NRC RAI 1-1:

Provide tolerances on the licensing drawings.

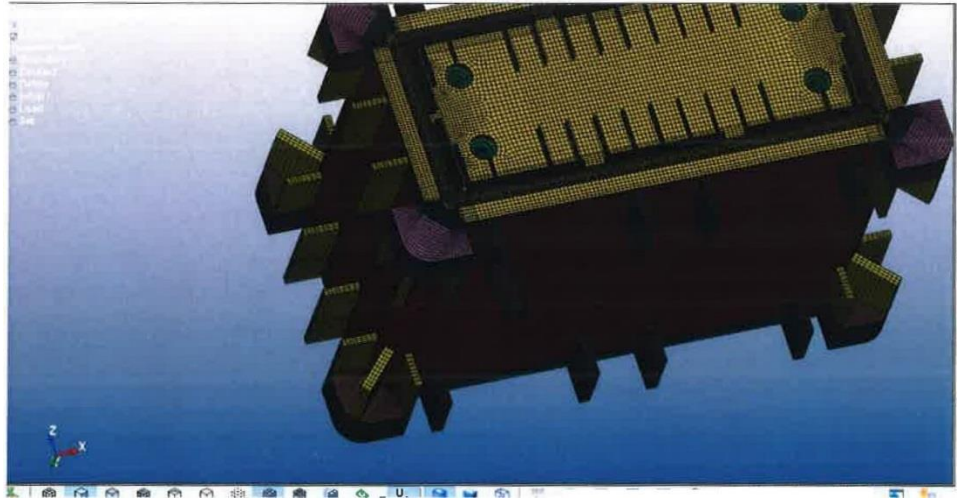
As stated by the applicant, the ratio of hourglass energy to internal energy should be kept to a ratio of 10% or less, as hourglass energy indicates that a nonphysical part of internal energy is present in the model, which, in turn, implies that deformations and the overall physical behavior of the part may not be realistic simulated.

Several drop simulations, such as the 30 ft top end drop, exhibit ratios for certain parts which grossly exceed 10%; as an example, the top lid of the BTC (model part 29) observes a ratio of 130%, part 23 (intermediate dose blocker plate) in the model observes ratios of greater than 30%, and several others parts, not mentioned here, exceed 10% by smaller amounts.

In the revised analysis, it is ensured that:

1. The total hourglass energy is less than 10% of the peak internal energy of the cask.
2. The identical measure (ratio of total hourglass energy to the peak internal energy) for individual parts is also minimized to the extent practical without compromising the overall runtime.

The noted BTC components are also ensured to meet the above criterion.

It shall be noted, however, that the instantaneous energy ratios (viz. ratio of hourglass to internal energy at a specific instant) need not comply with this criterion. For example, in some instances, both the hourglass energy and internal energy magnitude during the start of the simulation is very small (< 10 lbf-in.), as compared to the total energy dissipation ($\sim 3.4 \times 10^5$ lbf-in.) for a particular component. In such cases, the exceedance of instantaneous energy ratio measure has no significant adverse effect on the cask dynamic response or the stress/strain results.

Puncture Bar Centered over Sealing Surface at Side Impact Absorber
(Side Drop Orientation Shown)

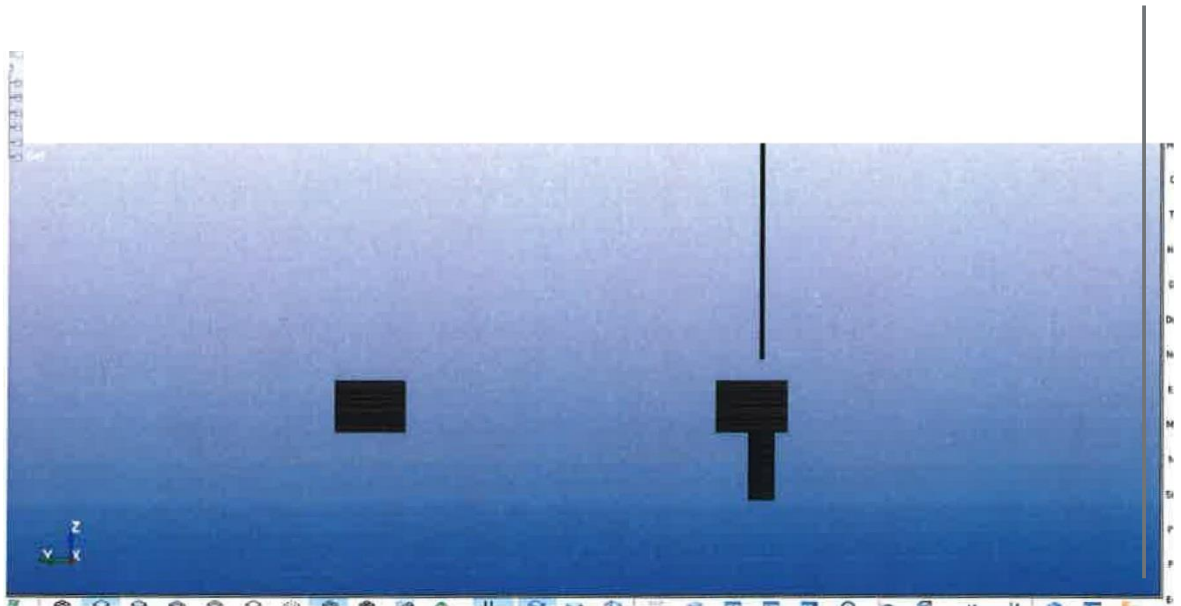
The package's sealing surface (cladding) experiences inelastic deformations after the 9 m side drop next to the side aluminum impact absorbers (BOM 42 of the licensing drawings). It appears that additional damage could be experienced in this region as a result of the 1 m puncture drop (cumulative damage) in the area as shown:

Additional damage in this region could further hinder and jeopardize the package's ability to maintain containment regulatory requirements.

A justification that containment requirements, such as leak rates, will be met given inelastic deformations at the closure region after the 9 m side drop has not been provided (see also containment RAI 4-1). The applicant shall update the application and all associated calculations, as necessary.

To address NRC staff's concerns, an additional puncture simulation is performed as discussed in Appendix C of HI-2177539 Revision 4.

This sensitivity simulation considers a 1-m puncture drop wherein the cask is dropped sideways onto the puncture bar aligned with the seals. Furthermore, this simulation accumulates the damage and deformations (strains) from the 30-ft side drop as the initial condition before subjecting the cask to 1-m side puncture. The analysis and the results from this simulation are documented in Appendix C. The result summary from this analysis is the following:

1. Since the cask center of gravity is offset significantly from the sealing location or point of impact, the cask is subject to rigid body rotation before imparting any significant damage to the HI-STAR ATB 1T package.
2. The seal initial strain result from 30 ft. drop and the corresponding result subsequent to the final 1-m puncture drop remain unchanged. This indicates that the 1-m puncture does not contribute to additional deformation in the seals.
3. All other key containment results subsequent to the 1-m puncture drop remain essentially the same as its initial condition, i.e., 30 ft side drop simulation. There is superficial damage to the outer shell which is not critical for the safety determination of the package.

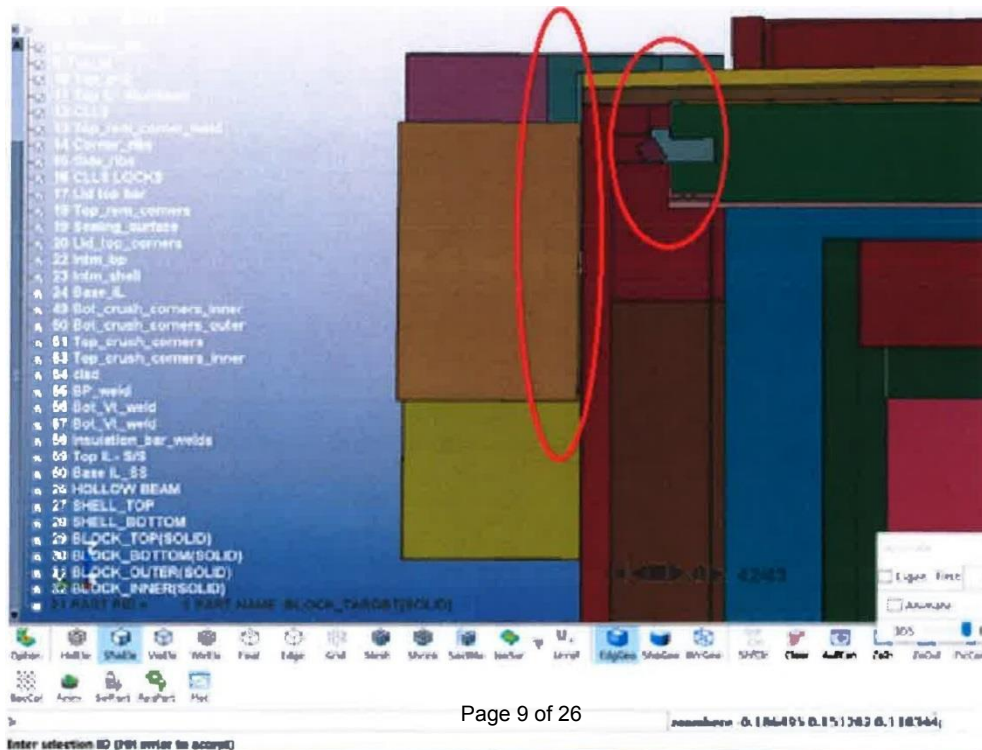
Licensing drawing 9786 (Sheet 7 of 7) depicts the relative arrangement between aluminum impact absorbers (BOM part 42). However, their location relative to the cask itself has not been provided. These plates are partially missing from the 1 ft bottom end drop, 1 ft top end drop, and 30 ft BOT CGOC + 1 m puncture drop simulations. In the case of the 1m drops, they also do not appear to be connected, as shown below. In addition, it appears that part 16 of the model, CLLS locks, rotates unnaturally through its neighboring parts.

Impact absorbers are intended to reduce the demands on the containment boundary. It is unclear how "loose" or "missing" impact absorbers will affect the package's performance. The applicant shall update existing drop simulations and the application as necessary, including the licensing drawings.

The revised dwg. 9786 shows the location/positioning of all the crushable attachments (impact absorbing components) relative to the cask.

It is correctly noted that some of the crushable attachments, which are not critical for a particular drop orientation, do not correspond to the actual sizing and positioning shown on the dwg. 9786. For example, the side attachment bars (i.e., part 42) are only shown for representation in the simulation model used for end drops. Likewise, the top and bottom bars are not critical when performing the side drops. This simplified representation is justified and is acknowledged in the calculation package HI-2177539 Revision 4. This modeling simplification has no adverse influence on the package safety determination.

It is also ensured in the revised calculation HI-2177539 Revision 4, that part 16 of the model viz. CLLS lock has proper contact with the adjacent cask components.

Figure 1: Plot of residuals at the end of the 30-minute fire (previous 200 iterations plotted for clarity):

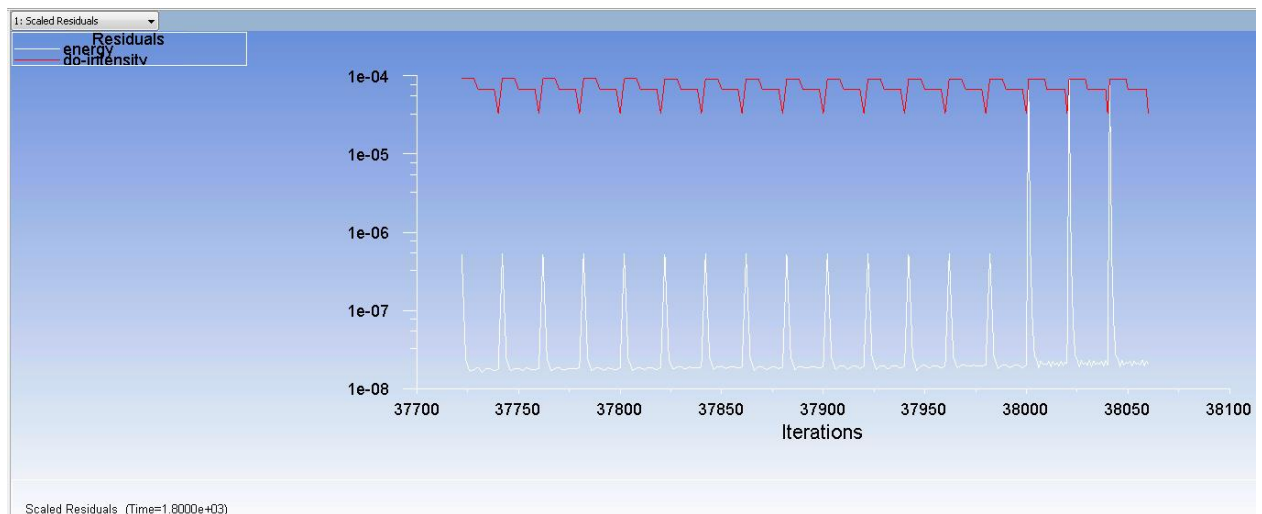
A review of the T200-half-uniform-1d75kw-fire-initial.cas file appeared to show an approximately 388°C external surface temperature 30 minutes after the start of the fire. This is different from expected temperatures, considering that the surface had been exposed to an 800°C fire for 30 minutes and Figure 3.4.1 from the previous application (Revision 1) reported temperatures over 750°C.

Recognizing the uncertainty in the temperature above and the presence of oscillatory-like swings at the end of the energy balance residual plot (T200-half-uniform-1d75kw-fire-initial.cas), the applicant shall demonstrate and clarify that the hypothetical accident condition thermal results have reached convergence (e.g., monitoring seal temperature throughout the timesteps) to ensure that reported values are representative.

Considering that the calculations have been updated, the response below is based on the calculations performed in support of the proposed revision 3 of the SAR and Rev. 3 of HI-2156585.

It is to be noted here that the containment boundary components, whose temperatures have been reported in Table 3.1.2 of the SAR, are not directly exposed to the fire boundary conditions. All the components exposed to the fire boundary conditions in the thermal model are listed in the table above. Neither in Figure 3.4.1 of the previous revisions nor anywhere in the proposed revision 3 of the SAR have the temperatures of the components listed in the above table been reported. The external surfaces of the cask that are directly exposed to the fire indeed show a maximum temperature of 662°C (1224°F), which is in line with the reviewer’s comments.

The transient fire evaluation is performed until all the containment boundary components reach their respective peak temperatures and start to recede. That is, the calculations are not extended until the closure lid seal temperature reaches an asymptote. This is because the maximum temperatures is already computed soon after 30 minute fire ends. The transient calculations are performed with large number of iterations per every time step which results in atleast 3 to 4 orders of drop in energy residuals as shown in Figure 1. Additionally, the converged mesh is adopted for the transient simulation to compute the closure lid seal temperatures.
